RHODE ISLAND DEPARTMENT OF TRANSPORTATION

RHODE ISLAND CONTRACT NO.2019-CB-027

Bridge Group 51A - Rt 37 C-2

ADDENDUM NO. 4 Prospective bidders and all concerned are hereby notified of the following changes in the Plans, Specifications, Proposal and Distribution of Quantities for this contract. These changes shall be incorporated in the Plans, Specifications, Proposal and Distribution of Quantities, and shall become an integral part of the Contract Documents.

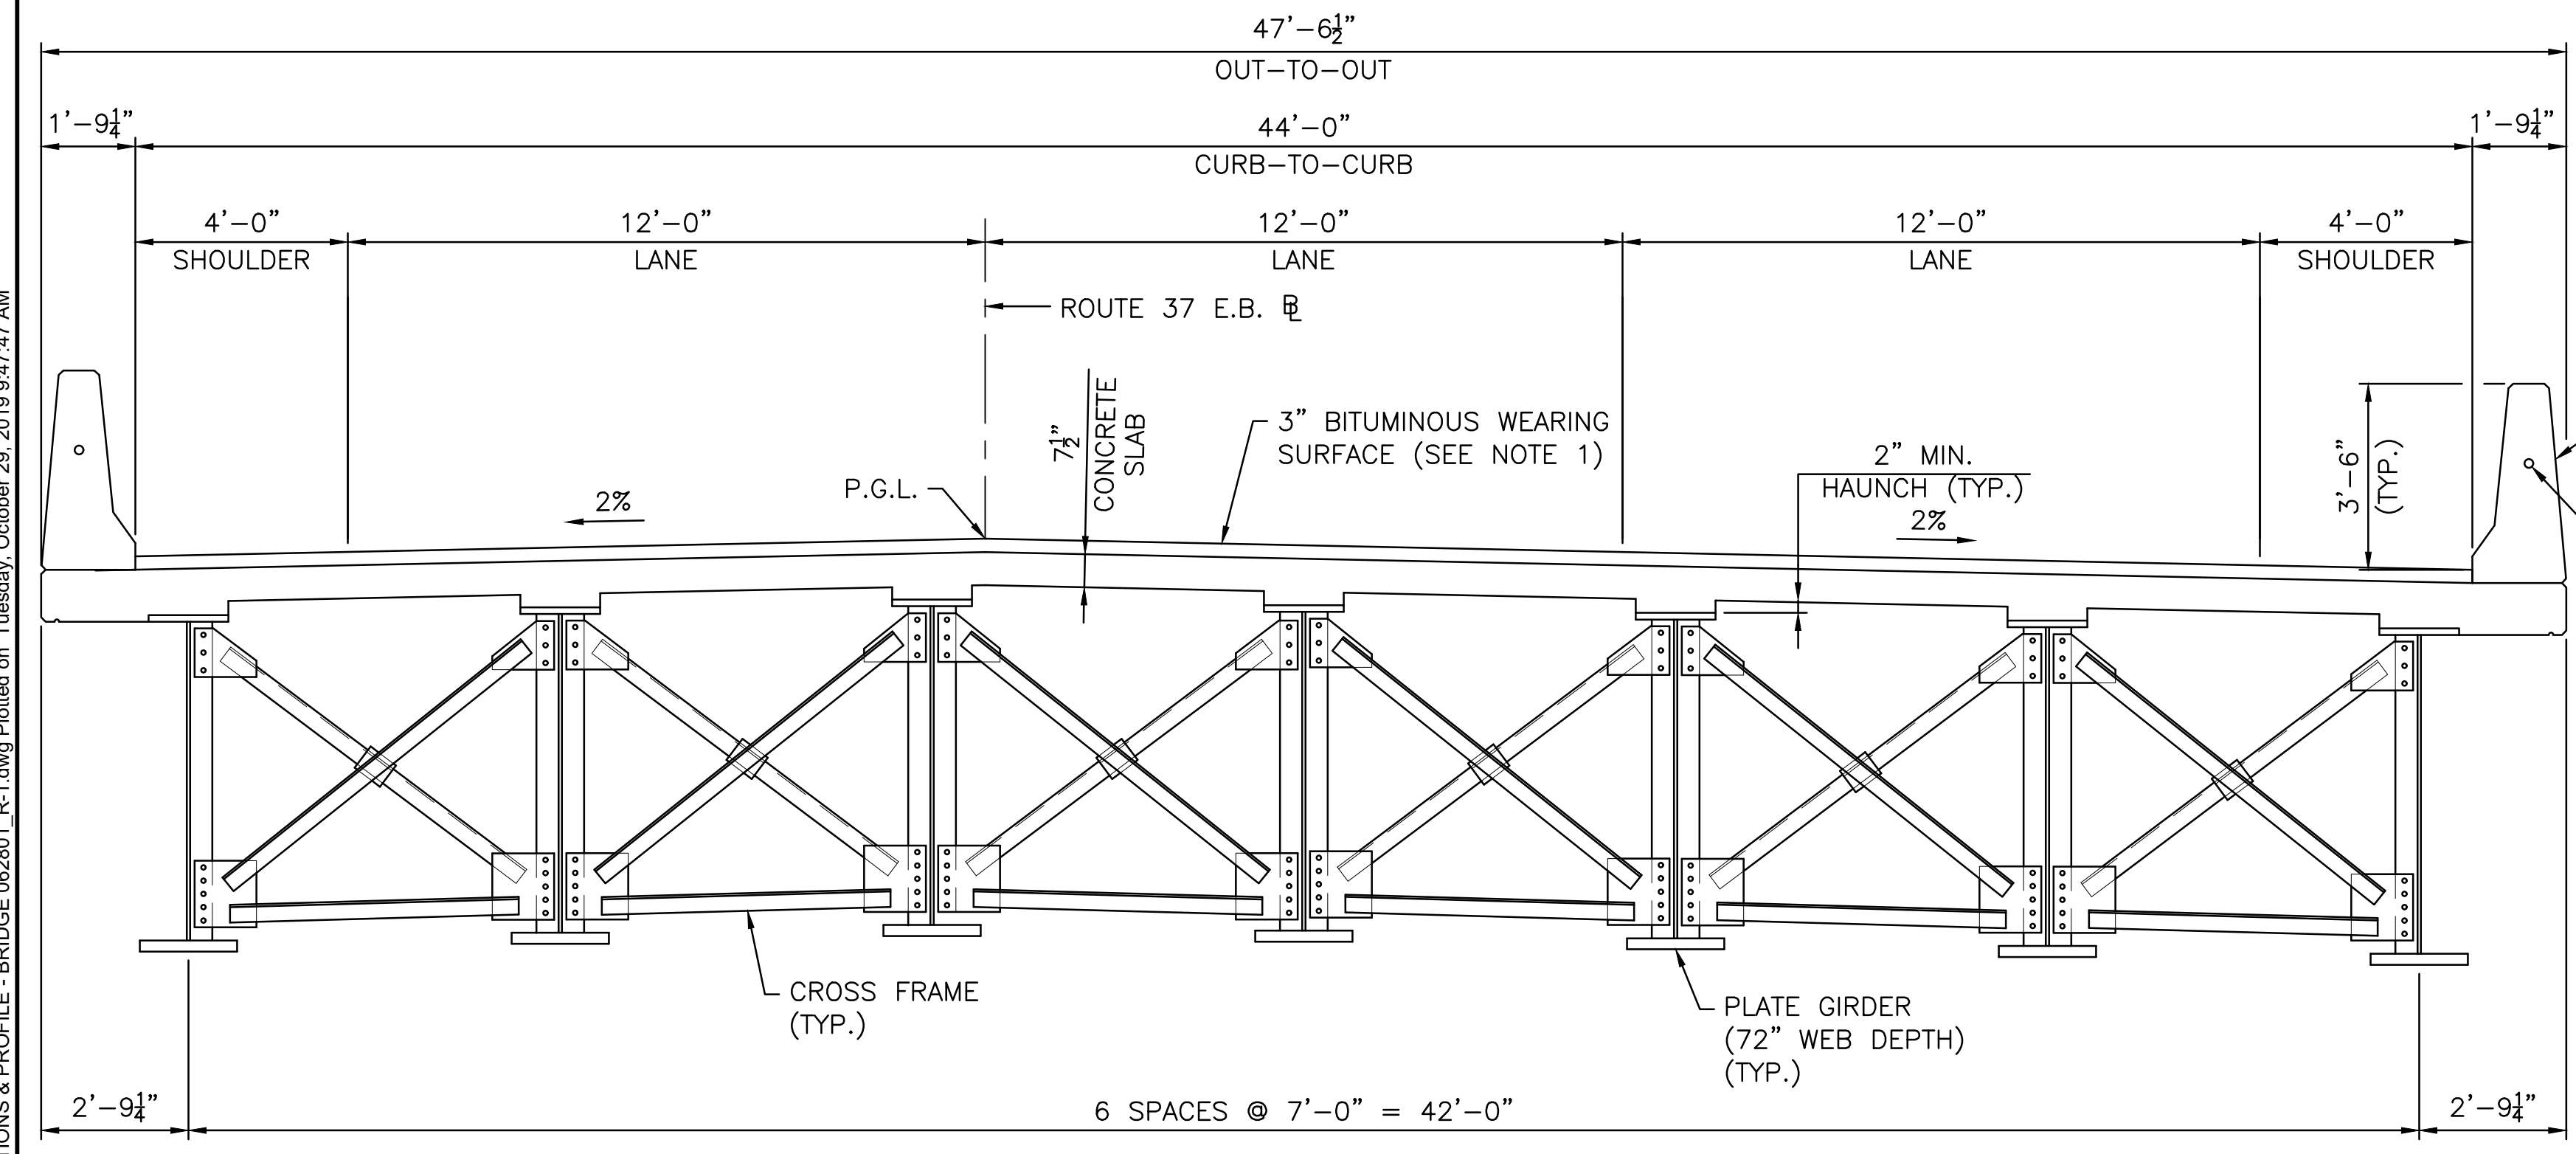
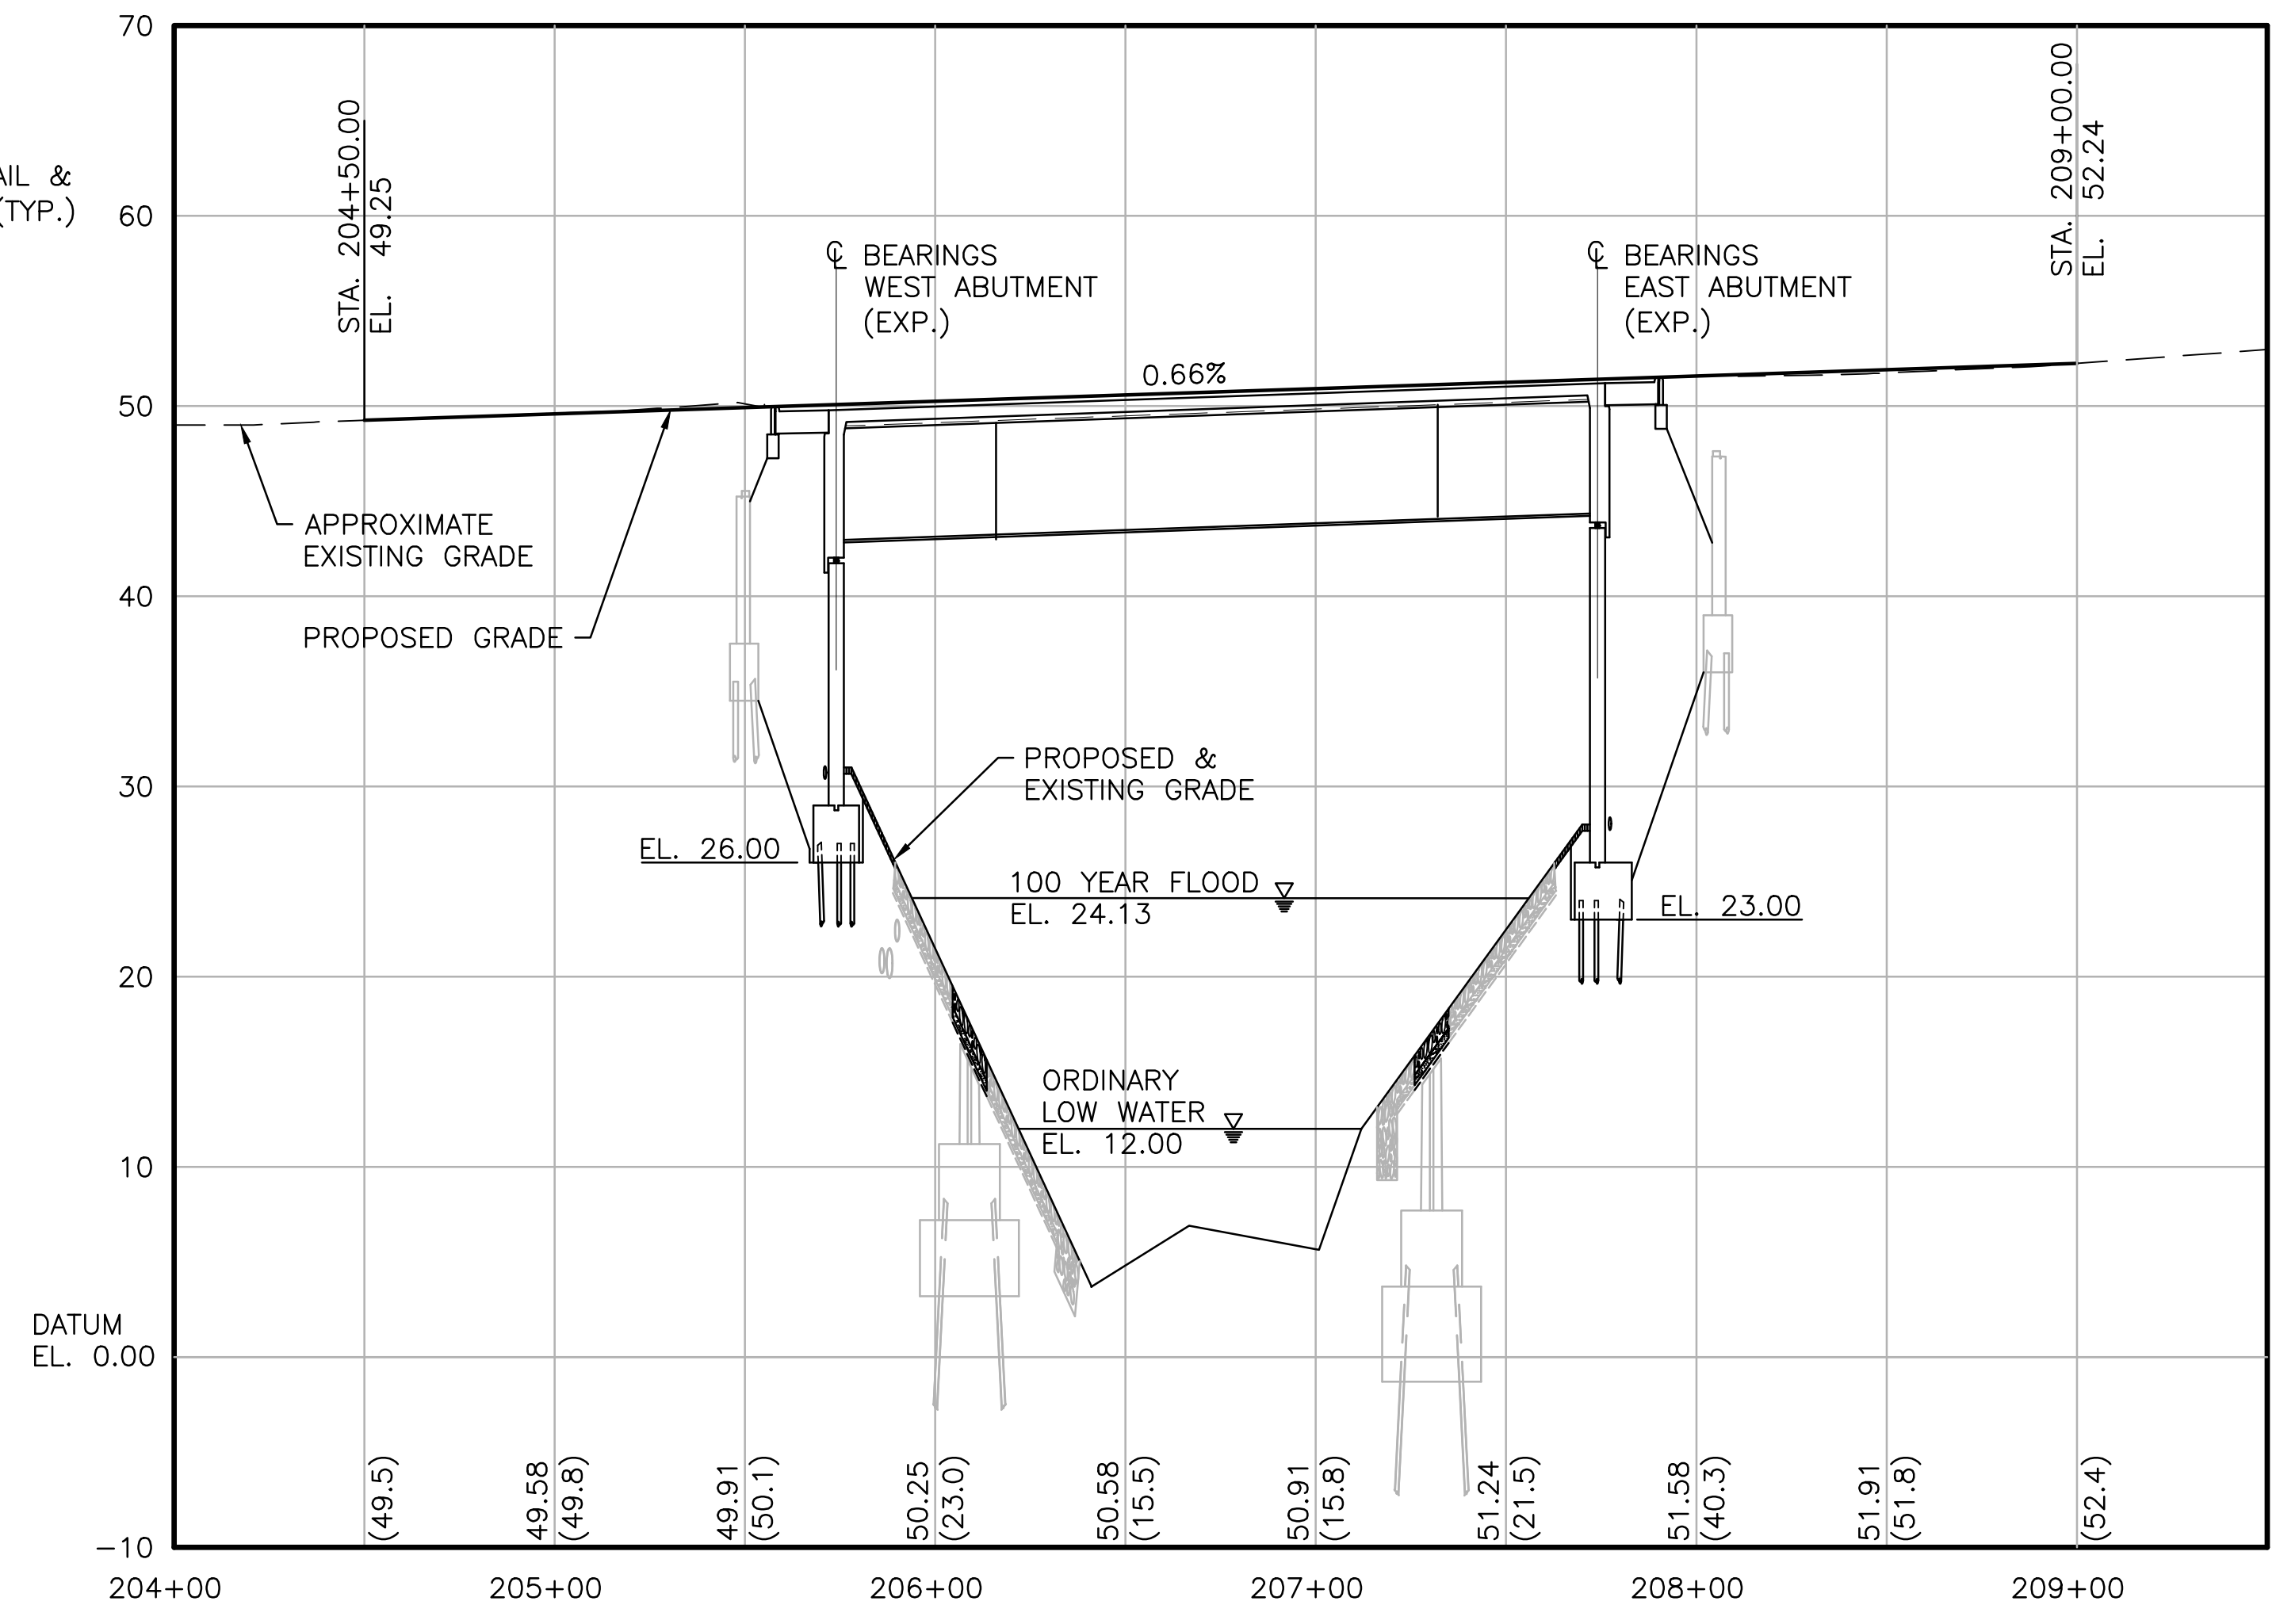
Delete plan sheets 6, 7, 24, 35, 37, 41, 48, 49, 64, 74, 75 in their entirety and replace them with Sheets 6 (R-1), 7 (R-1), 24 (R-1), 35 (R-1), 37 (R-1), 41 (R-1), 48 (R-1), 49 (R-1), 64 (R-1), 74 (R-1), 75 (R-1) attached to this Addendum No. 4. Various notes and callouts have been added or revised to clarify pay items and address other questions raised by bidders. In addition, the HMA wearing surface on the bridge deck and approach slabs has been revised.
